To: **Planning Reps**
From **Highways Development Management Officer**

Your Ref 20220687

Location 2 Salcote Road, Gravesend, Kent, DA12 4RB

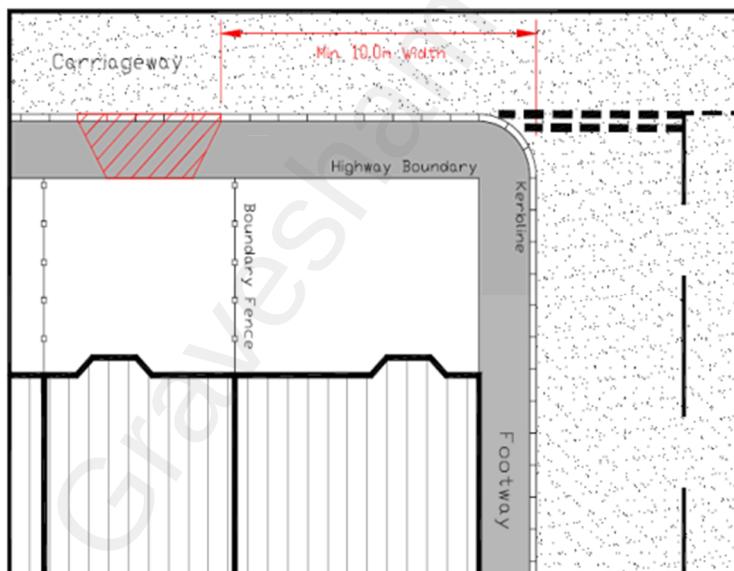
This application raises some concerns for which I do not have the answer. Any open space adjacent to the highway, irrespective of who owns the land could be public highway and have utility company or highway equipment buried in it. The applicant must confirm with Kent County Council that the land he intends to fence is indeed private with no highway rights of access.

In terms of the proposal, the property becomes a four bedroom dwelling and there appears to be little if any justification for providing two additional parking spaces, particularly when this would result in one space at least being within 10 metres of a road junction which Kent County Council consider unacceptable, as it can result in a highway hazard.

A single additional parking space would be acceptable if the land is not highway. In addition due to the additional bedroom, a secure cycle parking space is required.

Extract from Vehicle Crossing Guidance and Self-Assessment published by Kent County Council

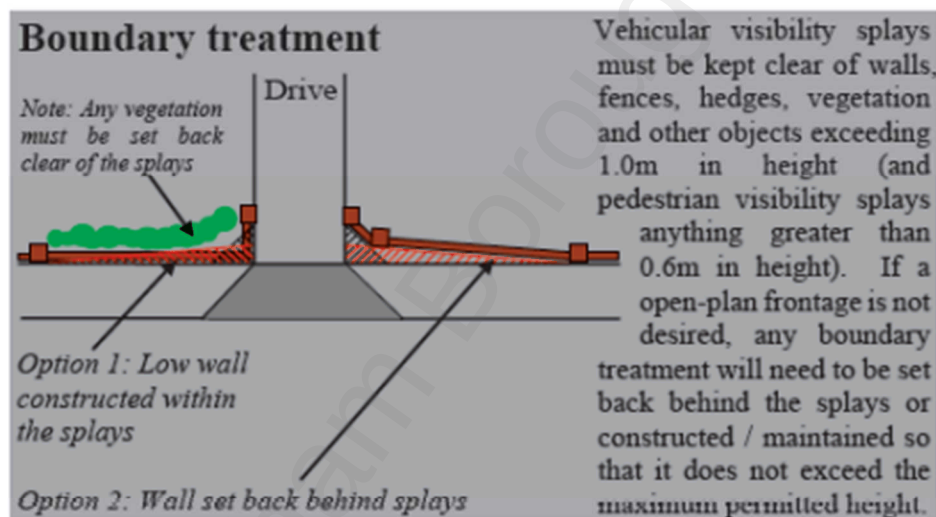
In terms of the fencing, 2m x 2m pedestrian visibility splays would be required down the side of the drive with nothing over 850mm in height within the splay.

Footway visibility

X-dimension 2.0m from back of footway

Y-dimension 2.0m within these splays,

There should be no obstruction to visibility between heights of 0.85m and 2.0m above footway level. If the footway is likely to be used by small children, the height should be reduced to 0.6m. Where all or part of the splay lies across land outside of the applicant's control, a relaxation to this requirement may be considered, taking into account the amount of pedestrian activity along the footway and the width of the footway.
